**WATTS BAR NUCLEAR PLANT (WBN) - UNIT 2 – ADDITIONAL INFORMATION  
REGARDING WBN UNIT 2 CORRECTIVE ACTION PROGRAMS (TAC NO. MD9182  
and MD9424)**

### **Response to Cable Issues Questions as a Result of February 10, 2009 Conference Call**

### Response to Cable Issues and Electrical Issues Questions from the March 17, 2009 Public Meeting

Figure 3.2.1.15-1 (For Watts Bar only)

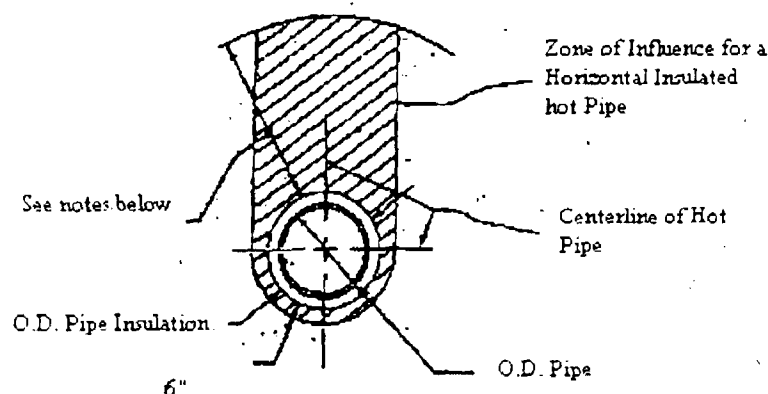
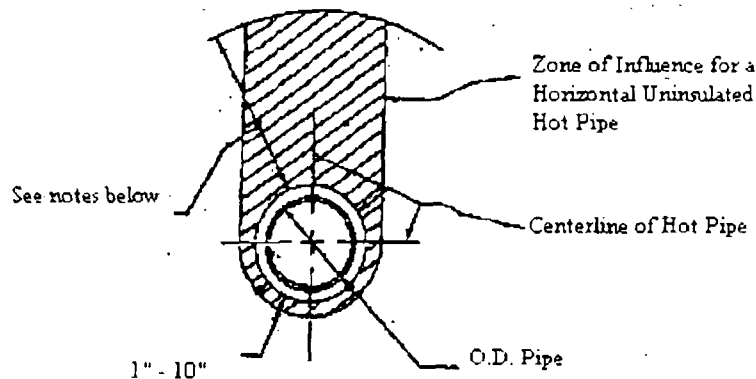
*NRC Question b: TVA to include the methodology used for developing the criteria for "Hot Pipe" configurations in the submittal.*

Separate treatment is required for different geometries that may exist in the plant. This is because certain geometries require significantly more clearance than others. Trying to force the more restrictive clearance requirements to be met for all geometries is not economical or feasible.

The geometries that were analyzed in the TVA calculation were considered to be sufficiently varied to cover the vast majority of cases that exist in the plant. However, if geometries existed that did not conform to any that were analyzed, specific analyses was performed for such cases.
